April 10, 2026

CASE NO: UDP-S25053
PROJECT: 11 North Andrews
APPLICANT: Bachow Fam OZ Fund, LLC
RE: Responses to DRC Comments Submittal #1

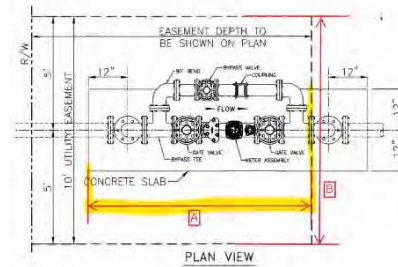
- c. Dimension proposed lane width on both sides of raised island for parking garage gate, which should be 12' (min.) per ULDR Section 47-20.5.C.3.b.i. Gates in open position shall not block adjacent parking stall, sidewalk, walkway, etc.

RESPONSE: The team is evaluating parking gate options that will comply. A 12' minimum lane width will be maintained on both sides.
